City of Santa Barbara
Community Development

Memorandum

SUBJECT: REVISED: Staff Report for Appeal Regarding 28 Anacapa St, Unit E

ENLARGED SITE PLAN - EXISTING AND PROPOSED

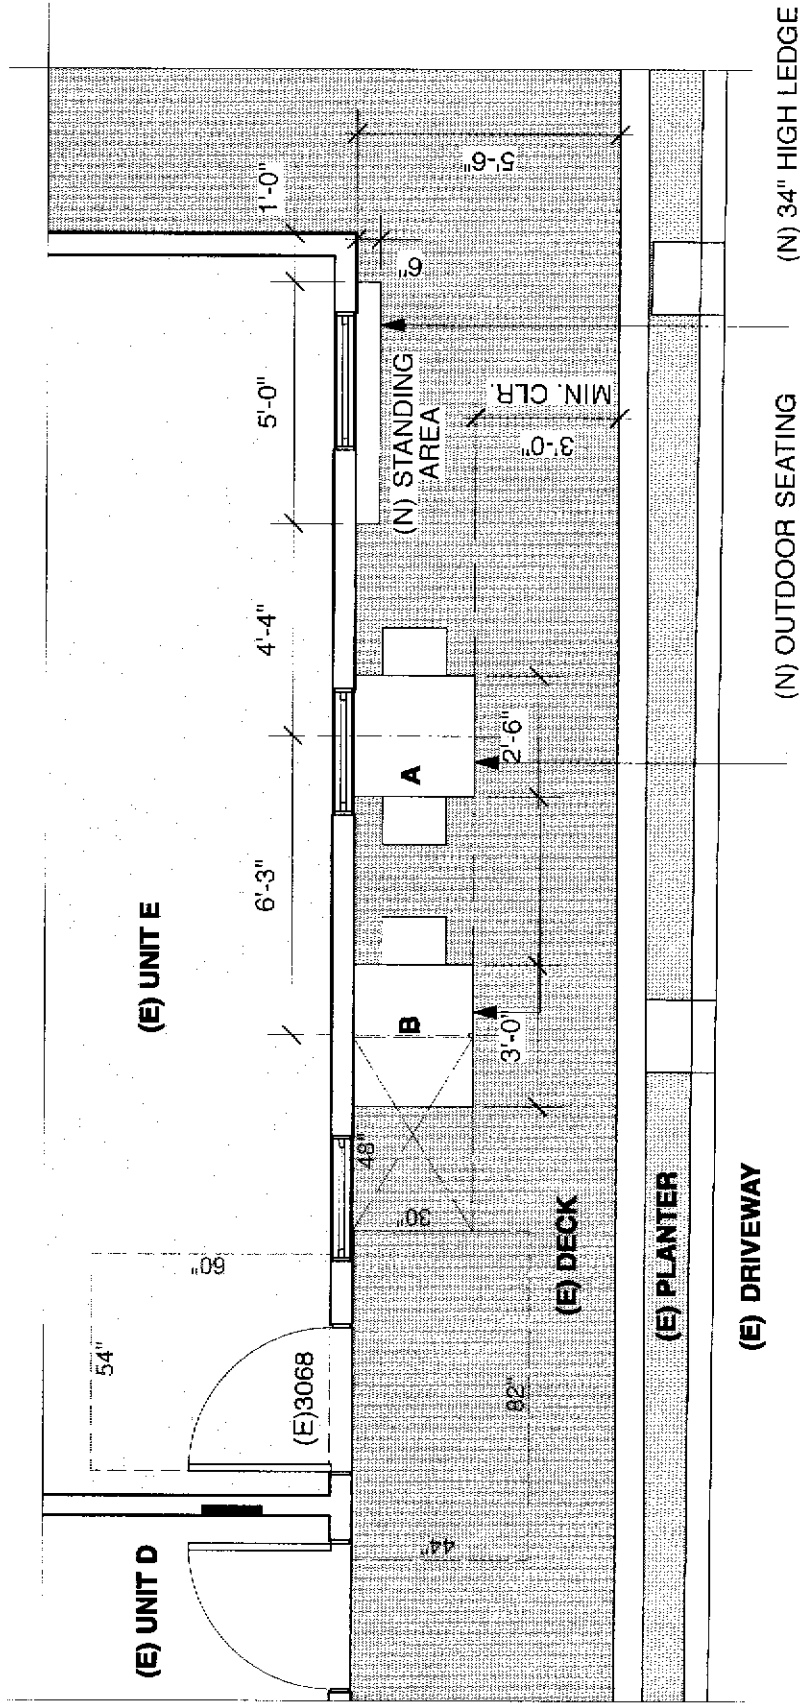
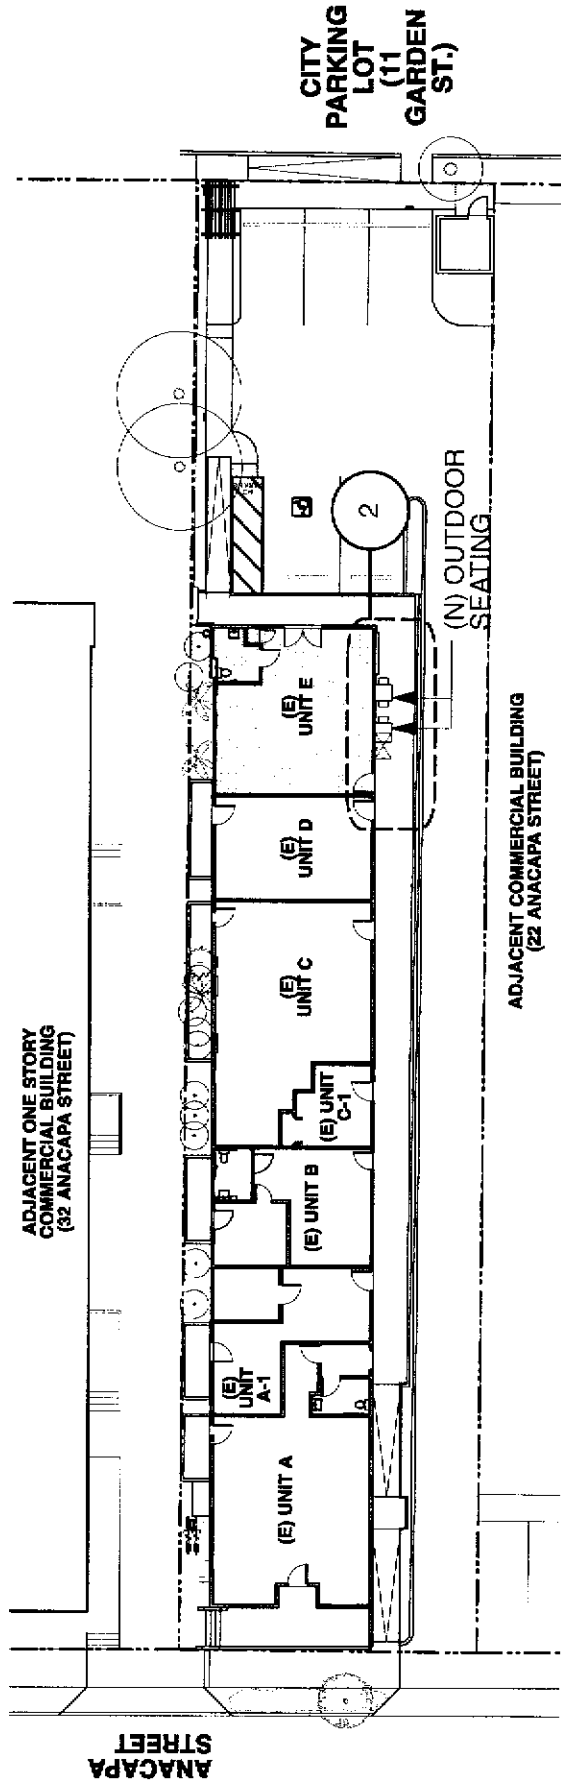
proposal is for new outdoor dining and standing area, not an existing condition.

3) As was discussed at the counter when this project was first proposed, the minimum 48" wide path must be provided for accessibility.

4) If the 48" wide path can be provided, new plumbing fixture calculations would need to be done for the unit associated with this proposal to ensure enough plumbing fixtures are provided for the new occupant load.

1) Add a note to the cover sheet of the plans stating "This project is within a FEMA Special Flood Hazard Area."

2) Show the elevation of the deck and the Base Flood Elevation on the plan so that it is clear that all work is above the BFE.
